**WHITE LAKE TOWNSHIP  
ZONING BOARD OF APPEALS  
REGULAR VIRTURAL MEETING  
May 27, 2021 at 7:00 PM**

**TO:** Zoning Board of Appeals  
**FROM:** Justin Quagliata, Staff Planner  
**DATE:** June 24, 2021

PROPOSED ADDITION FOR  
THE SUMMERS RESIDENCE  
7032 BISCAWAYNE AVE., WHITE LAKE, MI 48383

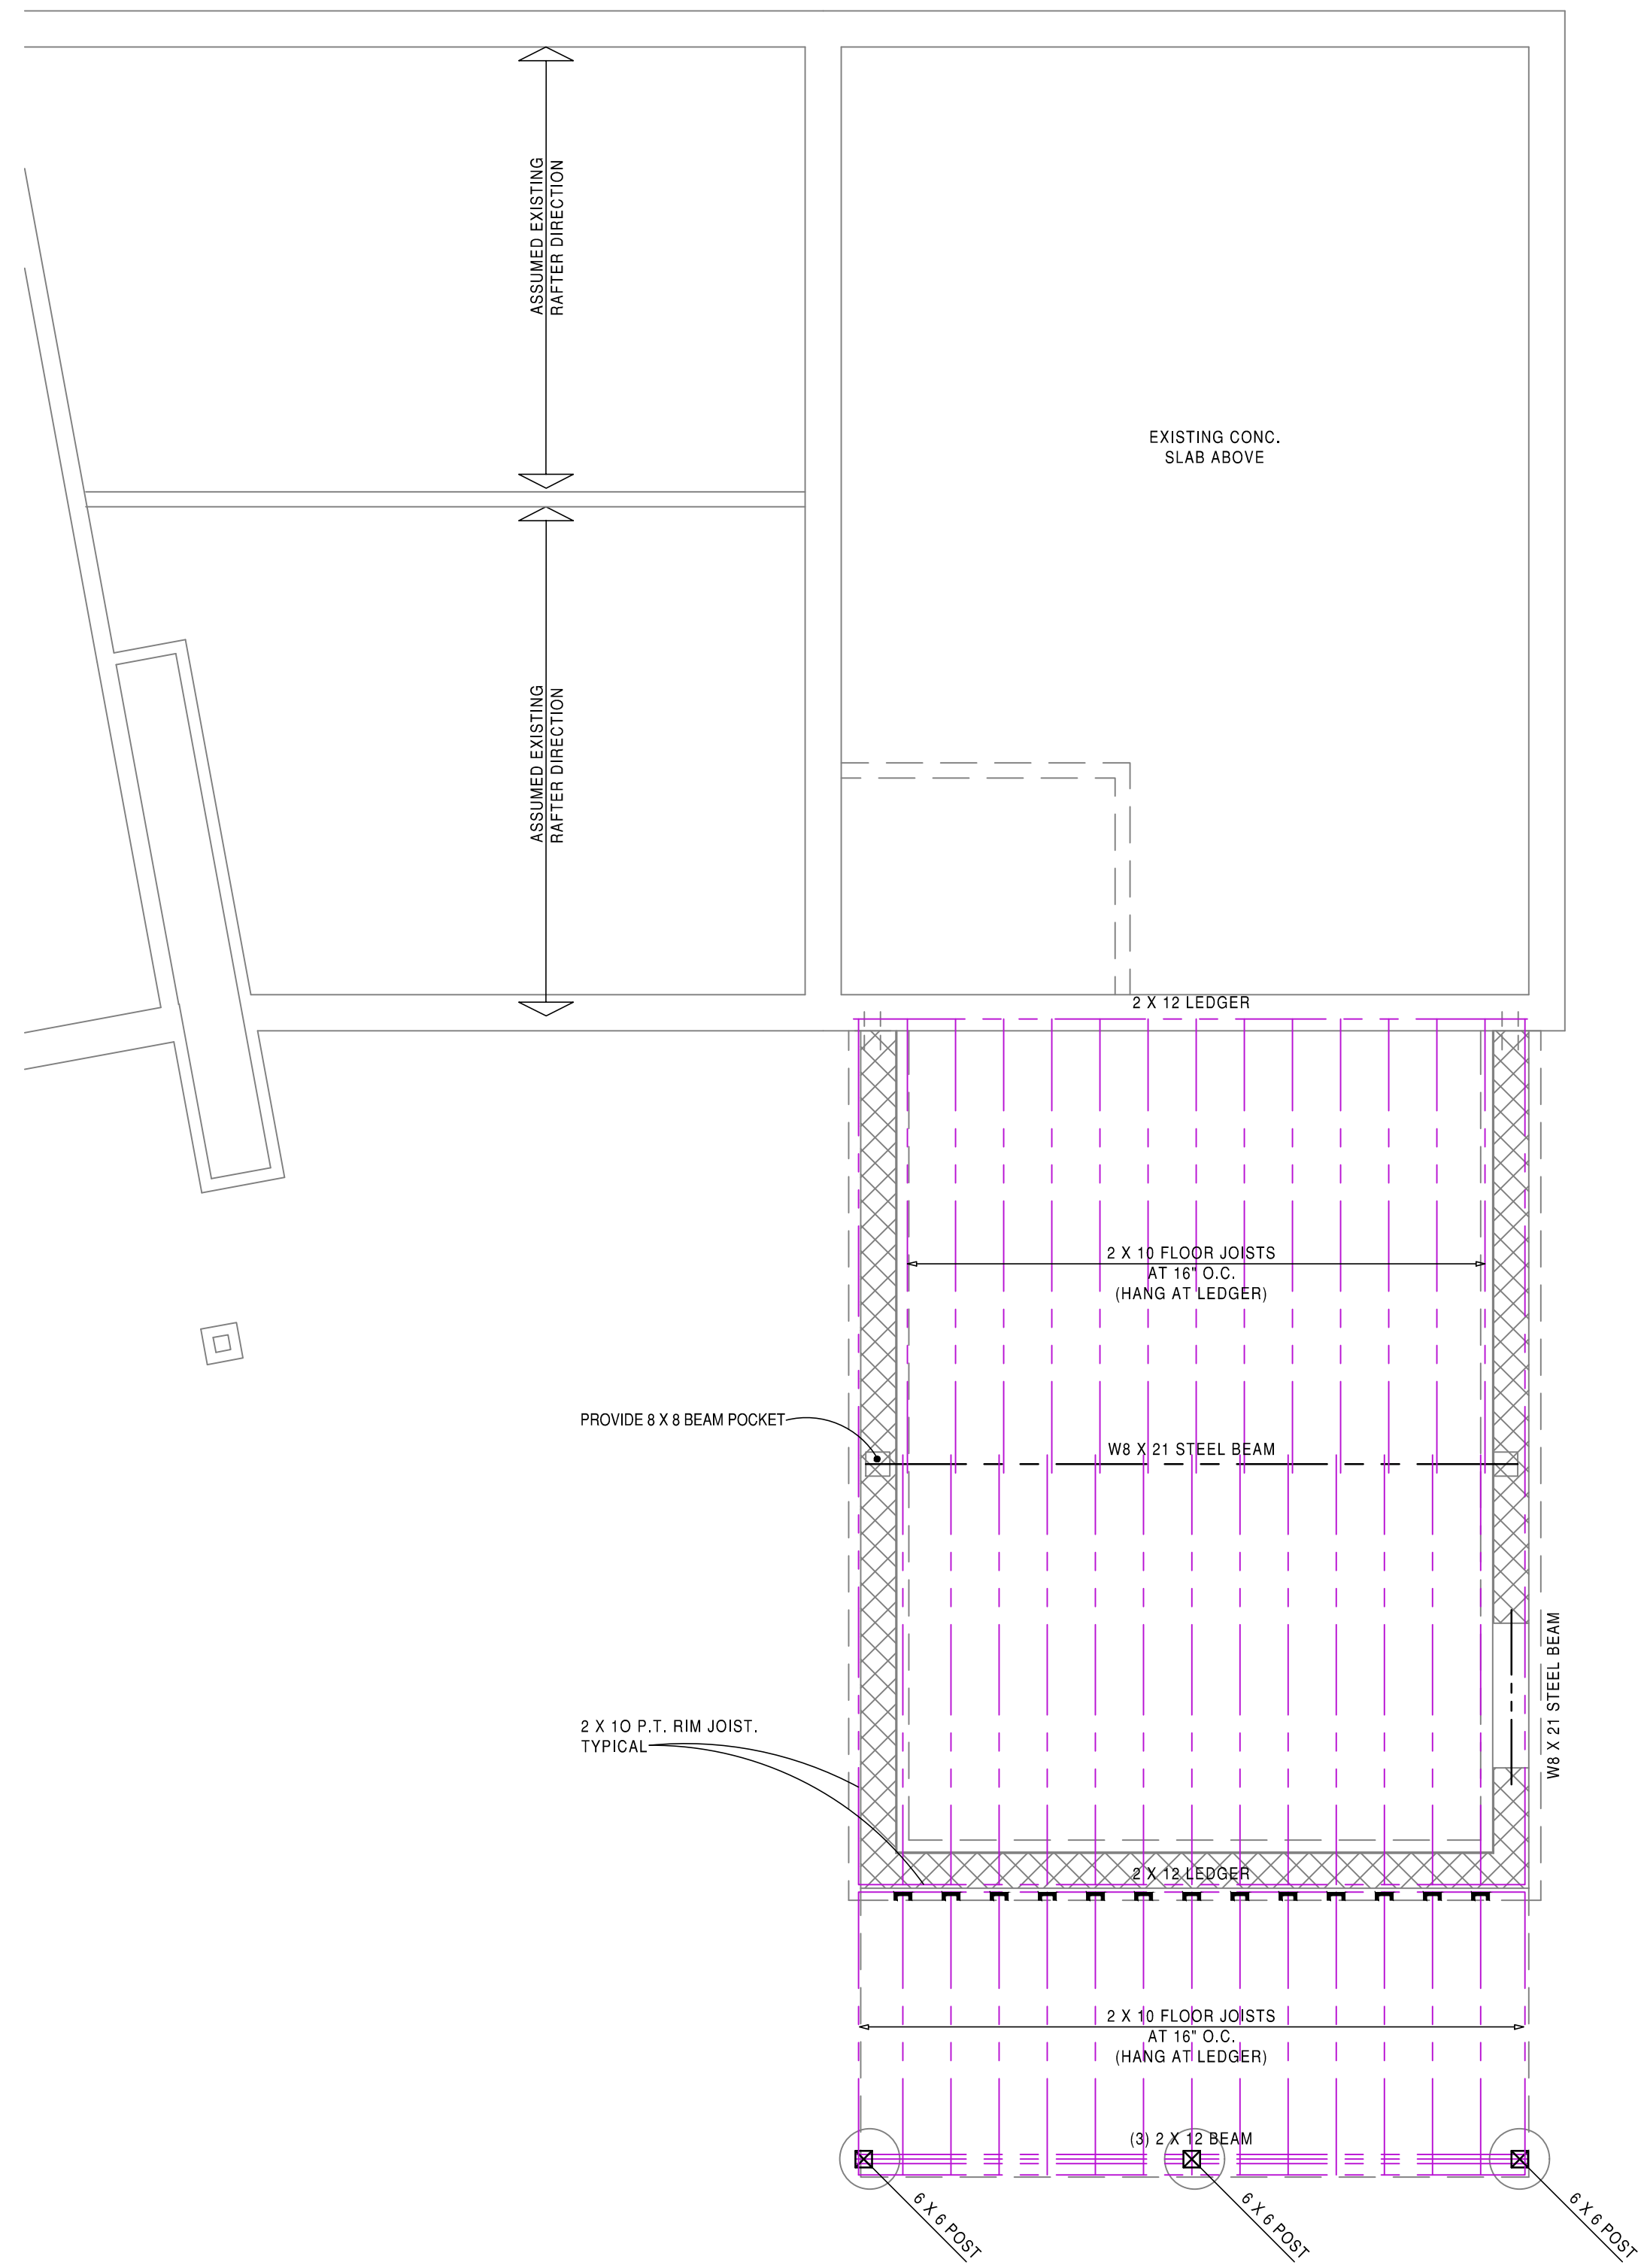
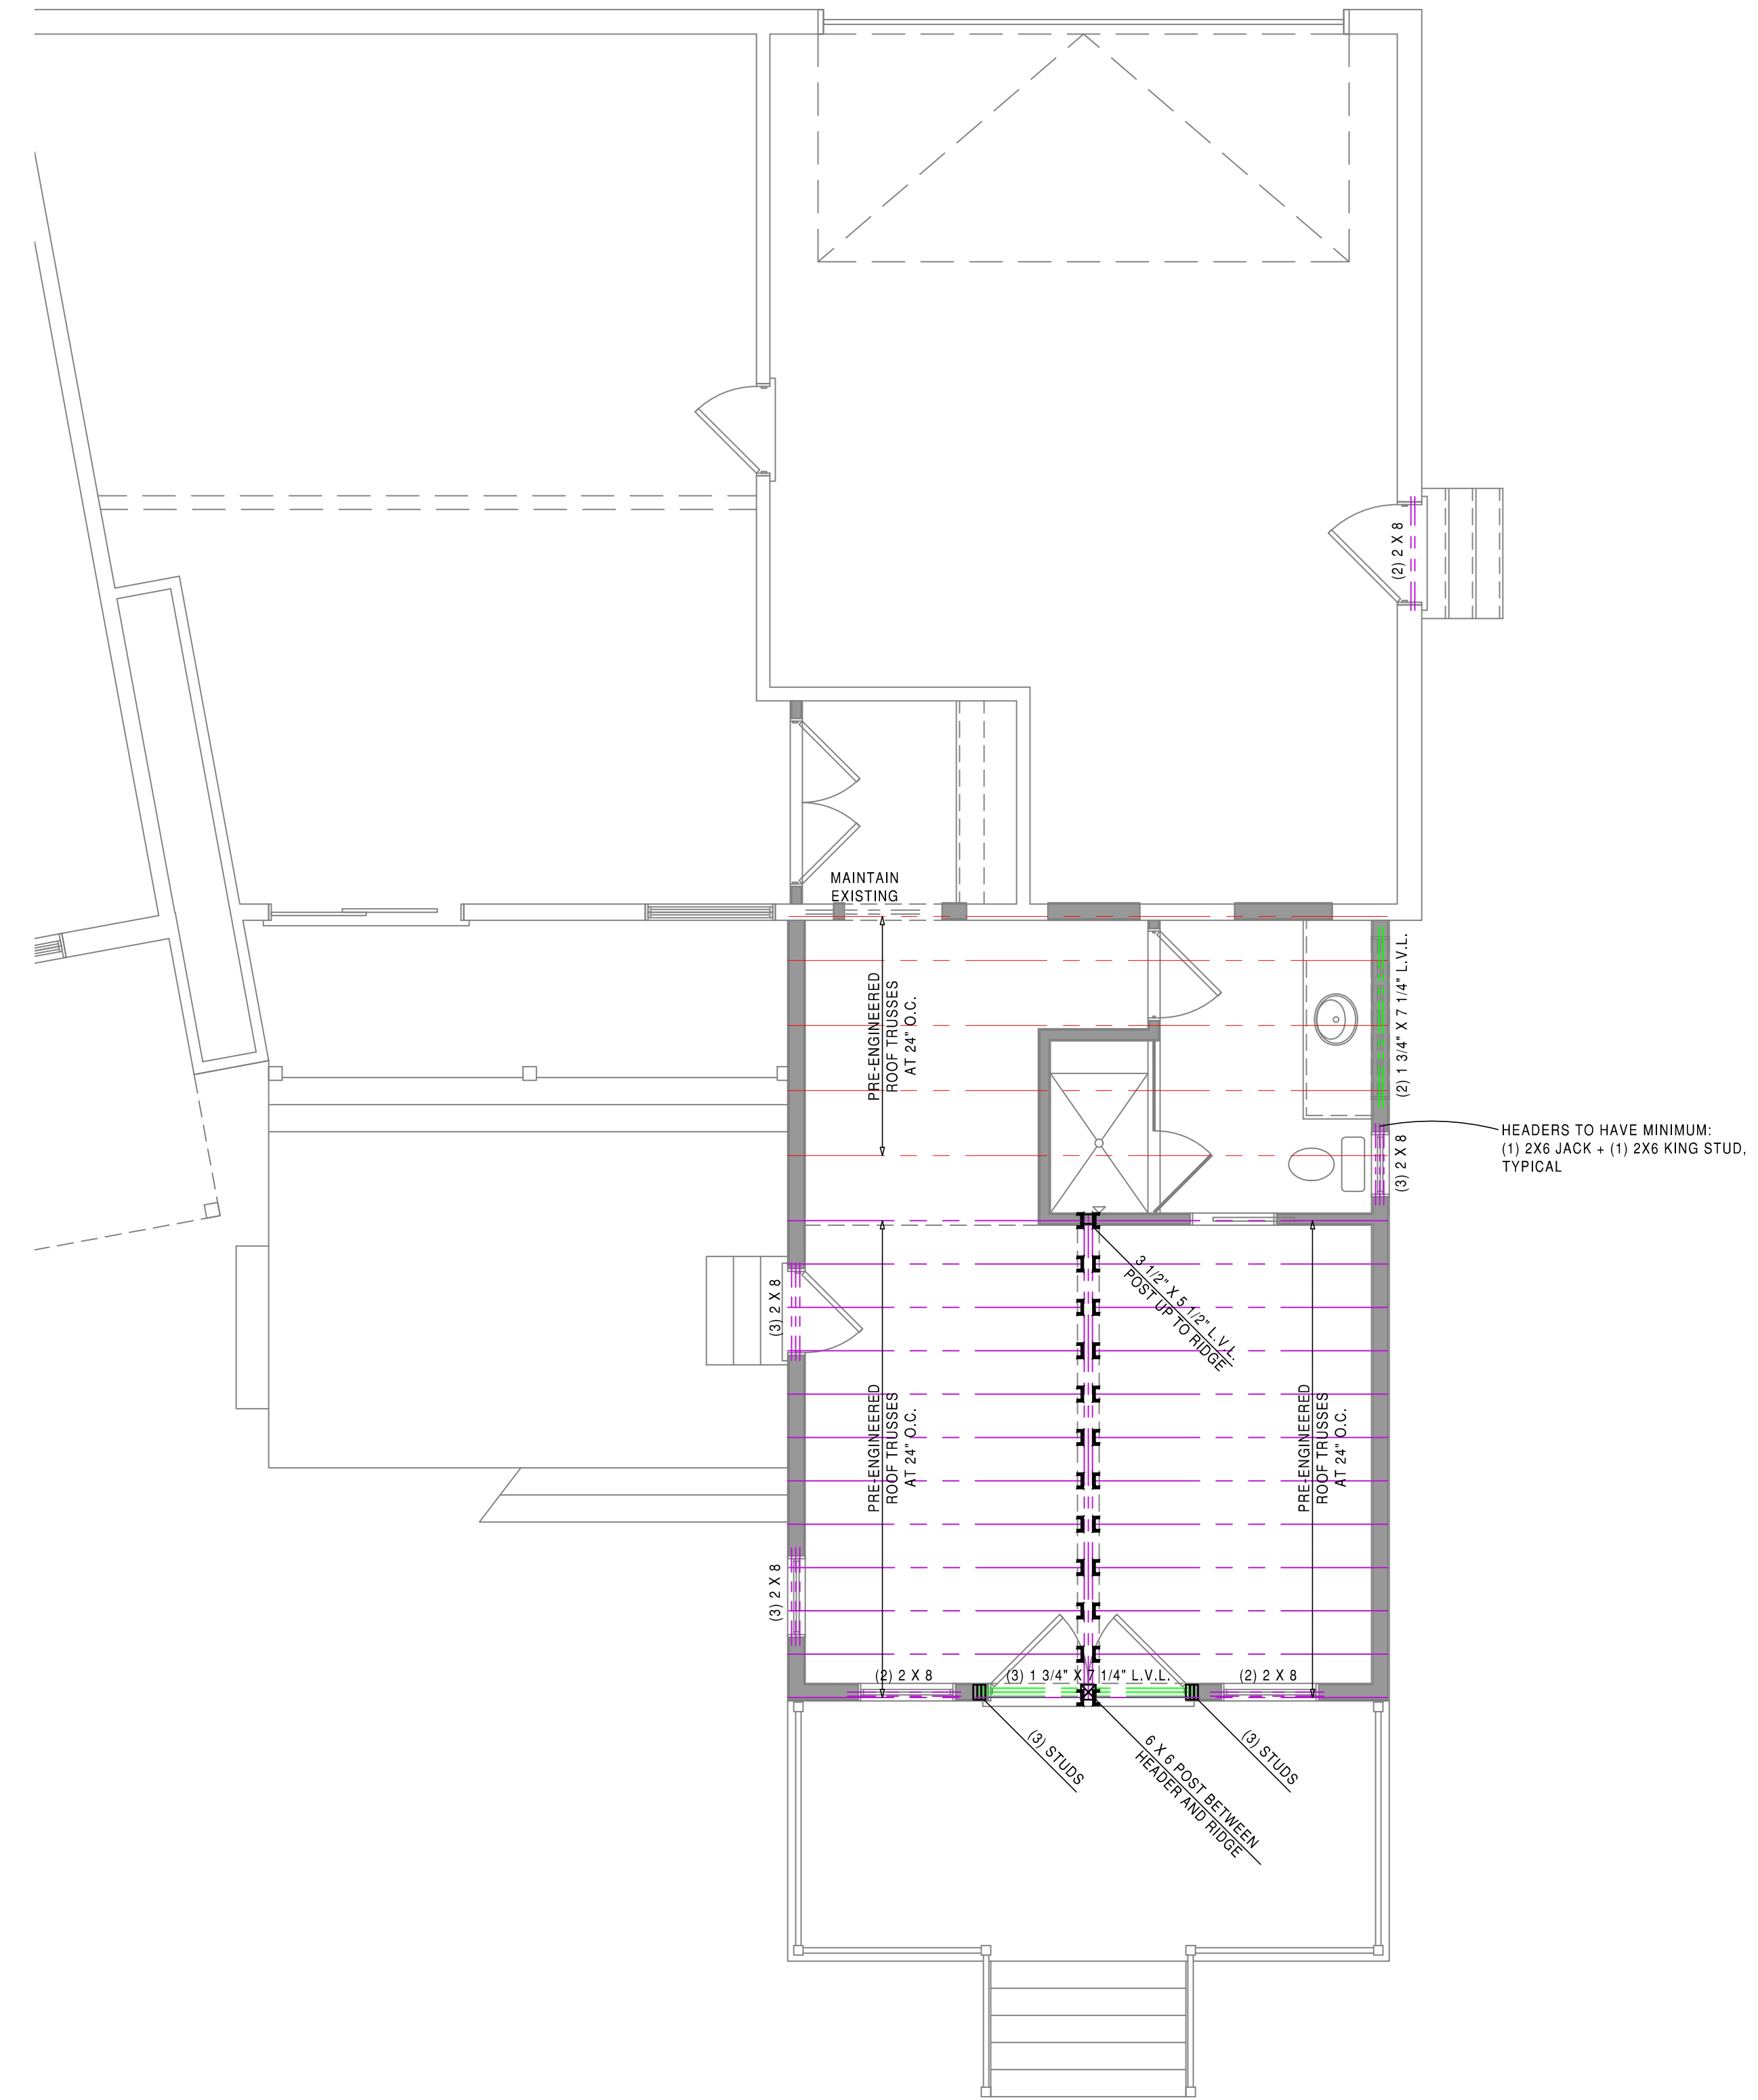
The proposed addition is 444 square feet in size and located six 6.6 feet from the east side lot line. The proposed deck is 148 square feet in size. The architectural plans note added area would be 535 square feet. The addition and deck total 592 square feet in size. Additionally, the architectural plans show the roof overhang of the addition located 5.25 feet from the east side property line. With the proposed side setback and 1.5-foot overhang for the addition, the roof would be 5.1 feet from the east side property line. If the Board approves the request, the plans need to be revised for consistency.

- The Applicant shall obtain all necessary permits from the White Lake Township Building Department.
- An as-built survey shall be required to verify the roof overhang setback from the east side lot line.
- The plans shall be revised for consistency to clarify the roof overhang setback.
